PROPOSED POPUP WINE BAR AT MARKET PLACE, MANLY NSW 2095

BUILDING CODE OF AUSTRALIA 2019 INCL AMENDMENT 1 REVIEW

Report Ref: 21-217486_BCA_R02

Date: 21 October 2021

The current situation at 6 October 2021

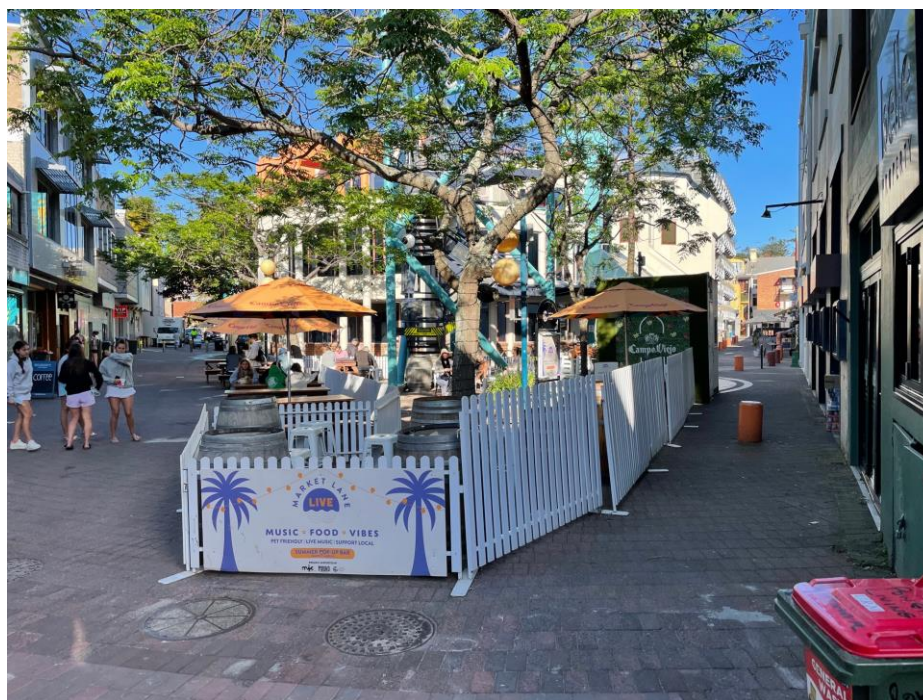
Part D1 – Provision for Escape - Complies as the entire area is not roofed and is effectively open space. Pursuant to Clause D1.10 the discharge of the Library egress stair cannot be impeded by the new works, in which case all tables, chairs and fencing must be kept clear of the stair egress gate shown below. *The new works will comply.*
